RE: Great Rivers Greenway District
Gravois Greenway
Orlando's to River des Peres Greenway – Phase 2
Federal Project No.: TAP + STP 9901(632)
GRG Project No. 118A
Addendum Number 1

TABLE OF CONTENTS – ADDENDUM NO. 1

ITEM NO. 4 – REVISIONS TO CIVIL DRAWINGS

ADDENDUM TO C.600

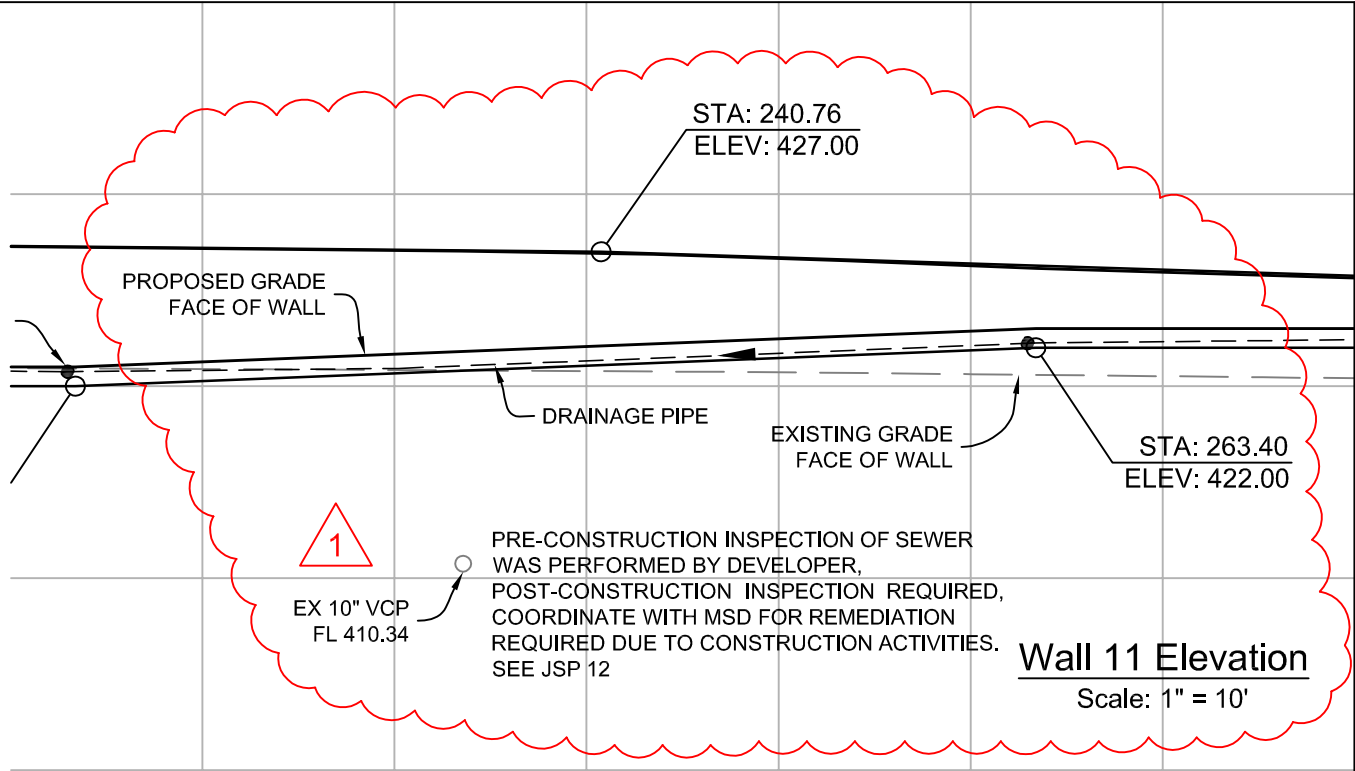
THE FOLLOWING NOTES SHALL BE ADDED:

Notes regarding JSP 701 - Ground Improvement (Delegated Design Walls)

- Based on Borings P-24, P-26, B-15 and B-16, it is anticipated that Ground Improvement per JSP 701 will be required for portions of Wall 15 and all of Walls 23 and 29.
- Anticipated limits of Ground Improvement are shown in the cross sections (C.408, C.409, C.416 and C.417).
- Anticipated limits of Ground Improvement are not shown in the Typical Sections for Walls 15 and 23.
- Anticipated limits of Ground Improvements are not shown in the Wall Plan and Elevation sheets.
